## Product Change Notice (PCN)

Amphenol Sine Systems

<b>PCN Number:</b>	<b>PCN-22001</b>		
<b>Amphenol Part No.:</b>	em eco mate® RM Back Shells - *See attached part listing		
<b>Origination Date:</b>	07/21/2022		
<b>Originator of Change:</b>	Dale Ryngaert		
<b>Change Status:</b>	<input checked="" type="checkbox"/> Permanent <input type="checkbox"/> Temporary <b>Effective Period:</b> _____ To _____		
<b>What is Changing?</b>	<input type="checkbox"/> Appearance <input type="checkbox"/> Material <input checked="" type="checkbox"/> Performance <input type="checkbox"/> Process <input type="checkbox"/> Size <input type="checkbox"/> Surface Treatment <input checked="" type="checkbox"/> Other Ease of assembly.		
	<input type="checkbox"/> Obsolete - <b>NO REPLACEMENT</b> <input checked="" type="checkbox"/> Obsolete - <b>WITH REPLACEMENT</b>		
<b>Reason for Change and Change Description:</b>	The enhanced EMI Shielding Clip will simplify cable prep & assembly where shielding requirements are needed. As a result, this is a rolling change and does not necessitate the immediate stoppage of the current EMI Shielding Ring. No impact to P/N description or price.

<b>Affected Products:</b> <i>[at

New Assembly Kit with Replacement EMI Shielding Clip

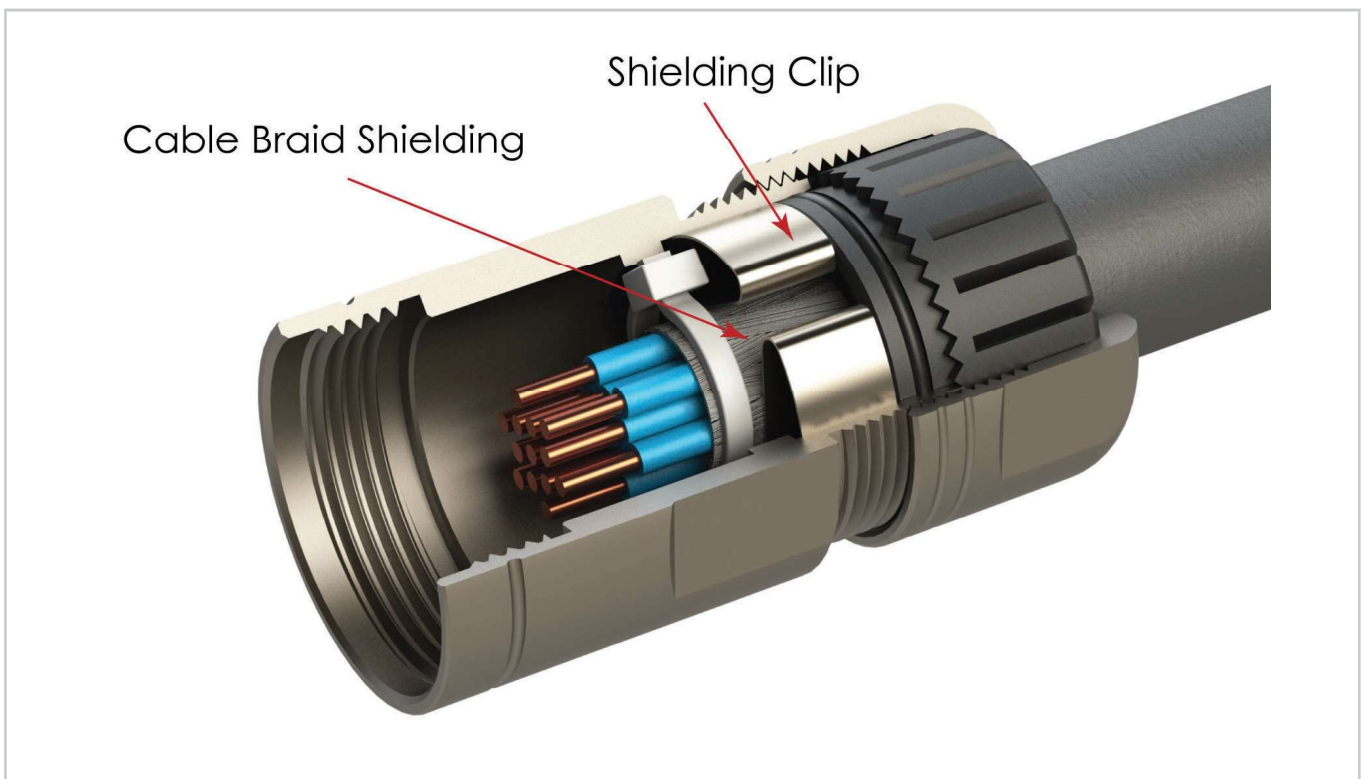
DISCONTINUED KIT COMPONENT	NEW REPLACEMENT KIT COMPONENT	NEW ASSEMBLY KIT
<b>EMI SHIELDING RING</b>	<b>EMI SHIELDING CLIP</b>	<b>REPLACEMENT EMI SHIELDING CLIP</b>
